CITY PLANNING COMMISSION

- APPLICATION:**
- A. Negative Declaration
 - B. Tentative Map to divide 11.2± net acres into 90 townhouse lots and one common lot
 - C. Special Permit for a 90 unit townhouse development

LOCATION: North side of Pocket Road between East Shore Drive and West Shore Drive

- SUBJECT:**
- A. Negative Declaration
 - B. Tentative Map Time Extension to subdivide 11.2± net vacant acres into 90 townhouse lots and one common lot in the Single Family Alternative, Planned Unit Development (R-1A)(PUD) zone.
 - C. Special Permit to allow for a 90 unit townhouse development.

Partial Site Plan
LOT 22 of Parcel 4 at Riverlake
Scale 1"=20'

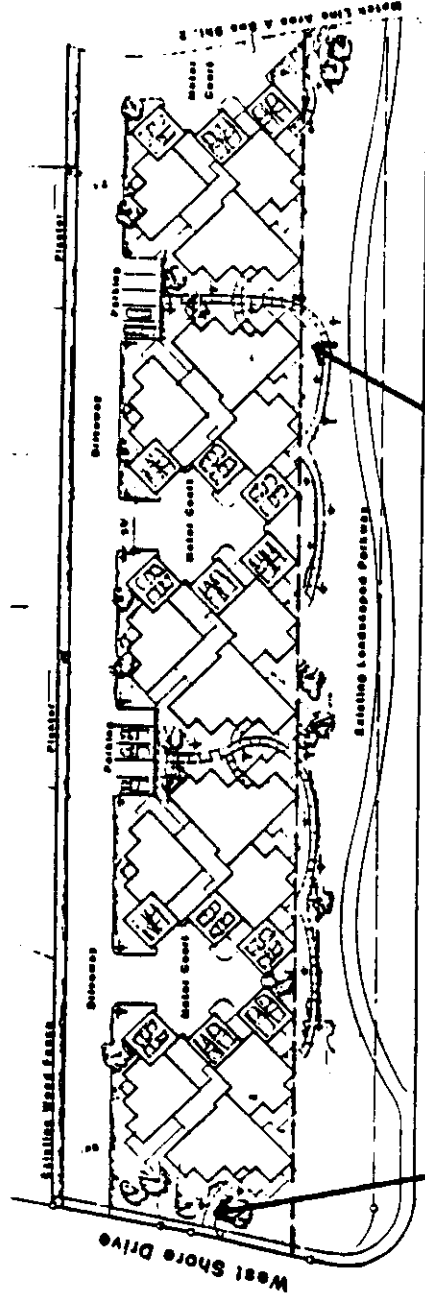
Remove all patio areas
from linear parkway
(example)

Remove all private walks
leading to public right-
of-way from landscaped
setback
(example)

- a. All parking spaces, patios, patio walls and/or fences and walkways connecting the residential units with the public right-of-way shall be relocated outside of the linear parkway and any required landscape setback or eliminated from the site plan.

Partial Site Plan
LOT 22 of Parcel 4 at Rivertake
Scale: 1/8" = 1'-0"

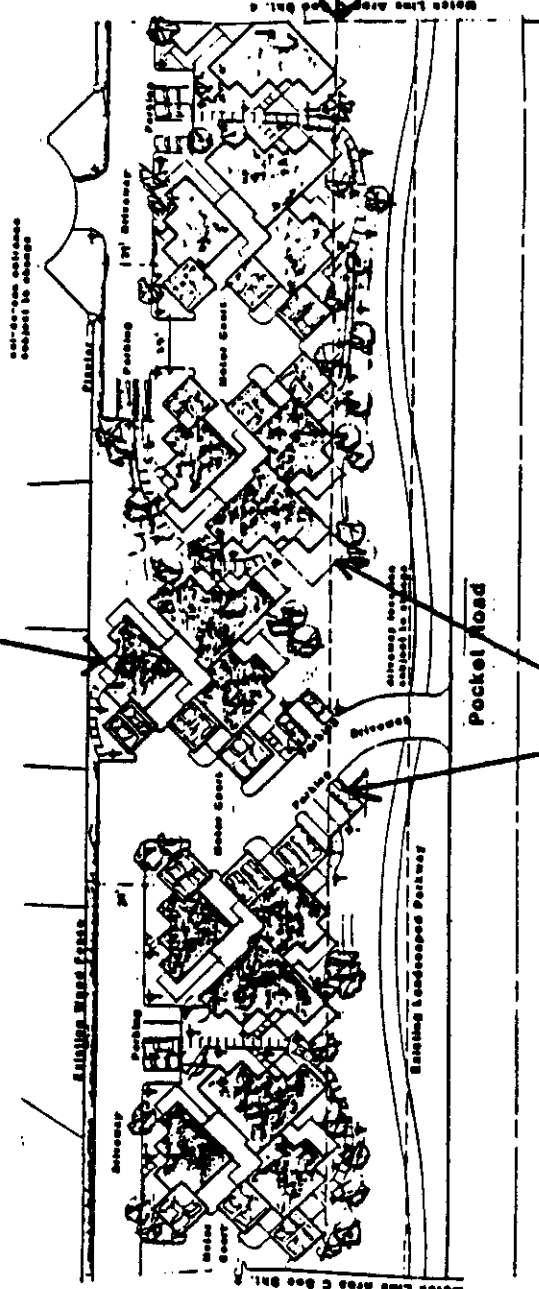
Provide minimum 10' building setback from north property line

Remove all parking and patio areas from linear parkway (example)

- d. A minimum 10 foot building setback shall be provided adjacent to the north property line.
 - e. A minimum of 10 feet shall be provided between the one-story portion of the building clusters and a minimum of 20 feet between the main entrances to units across from one-another shall be provided as shown in Exhibit F.

Partial Site Plan
 LOT 22 of Parcel 4 at Riverlake
 Scale 1"=30'

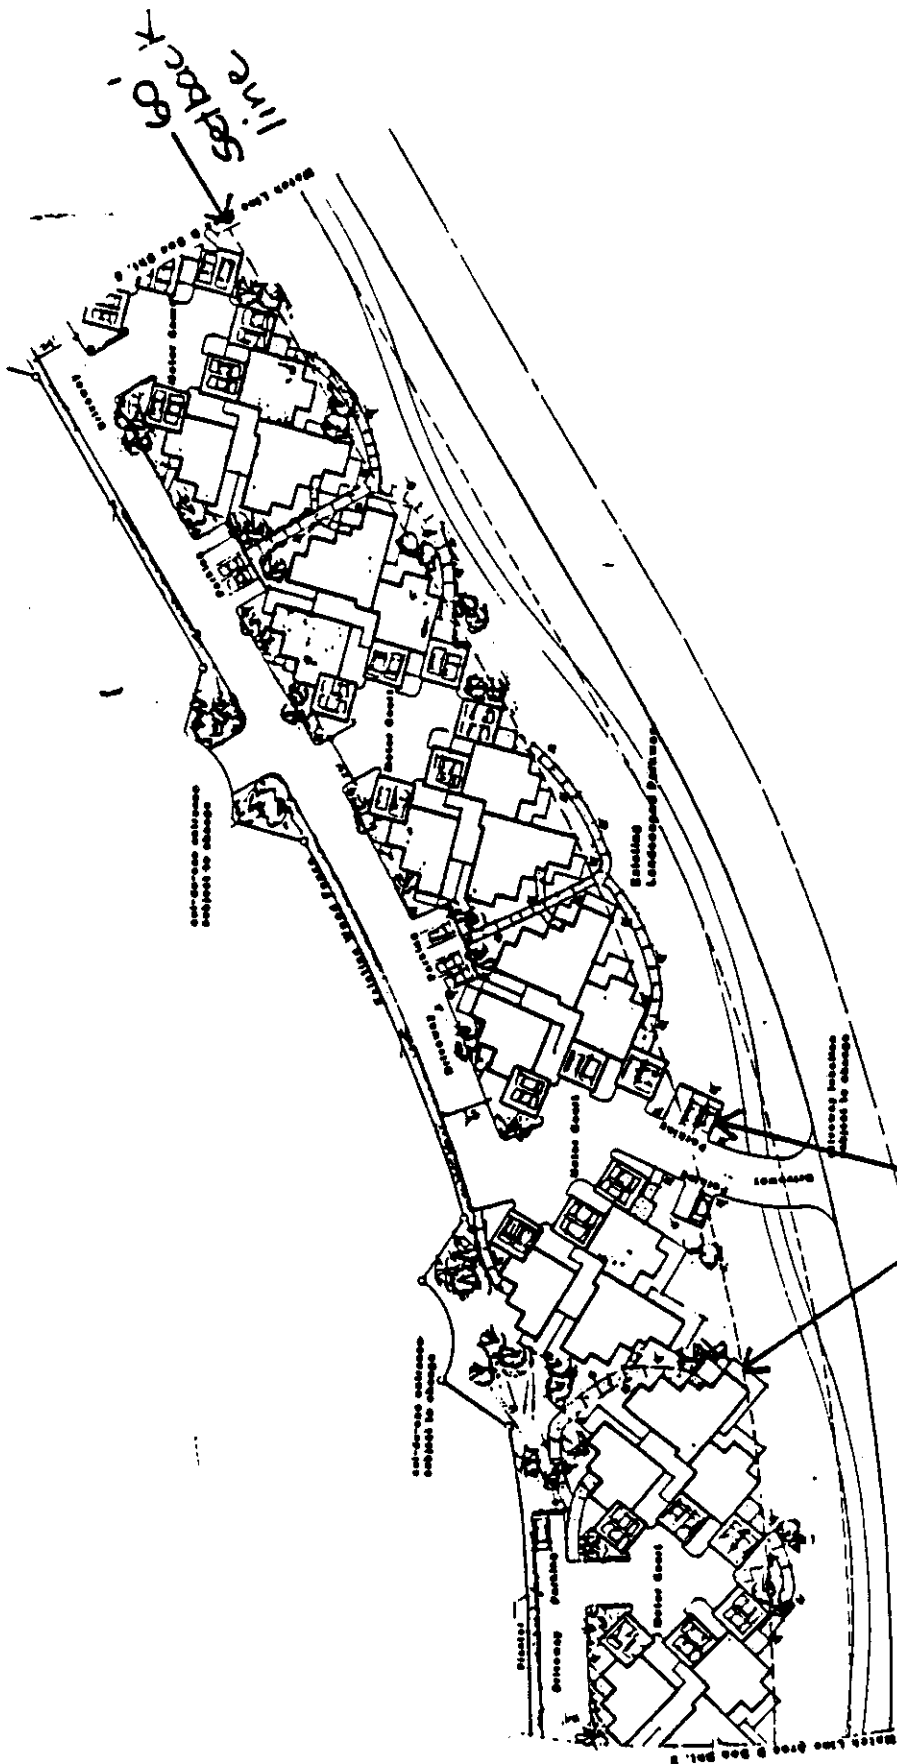
Remove all parking and
 patio areas from
 linear parkway
 (example)

Partial Site Plan
 LOT 22 of Parcel 4 at Riverlake
 Scale 1"=30'

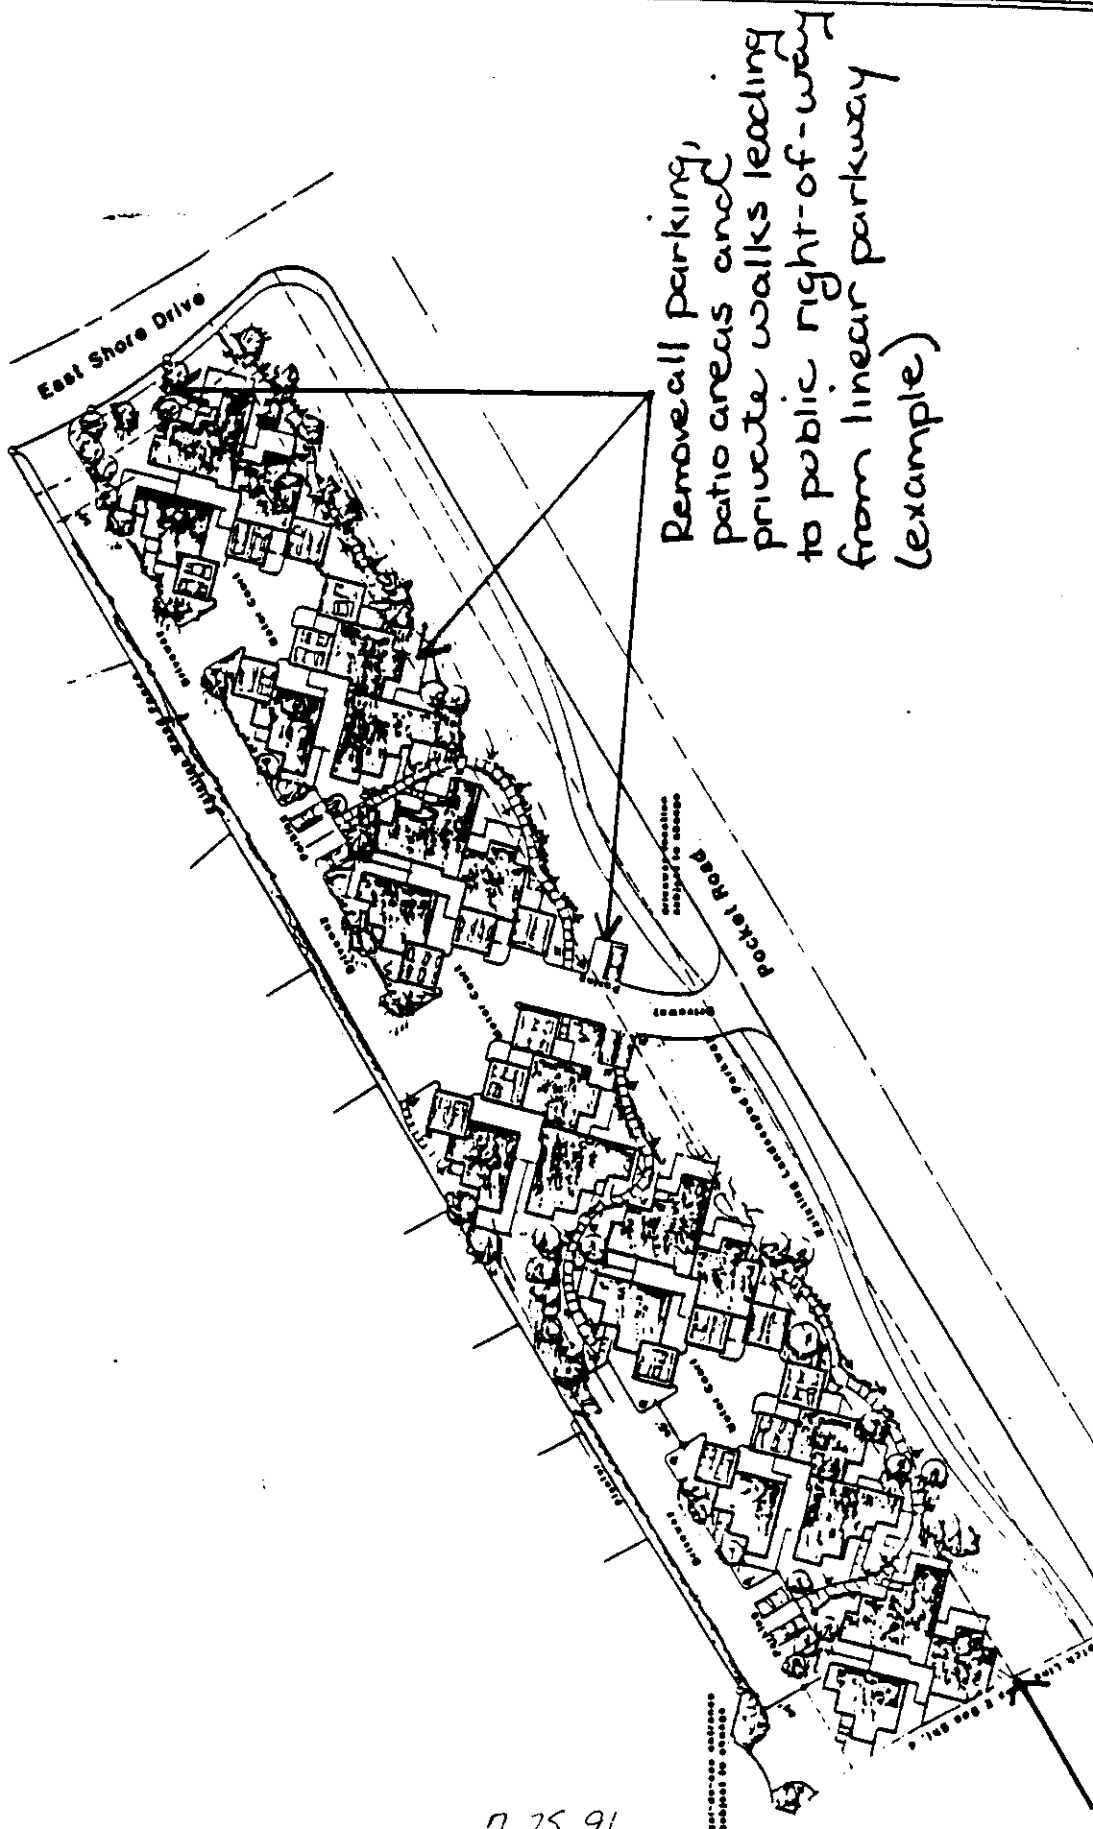
Remove all parking,
 patio areas and
 private walks leading
 to public right-of-way
 from linear parkway
 (example)
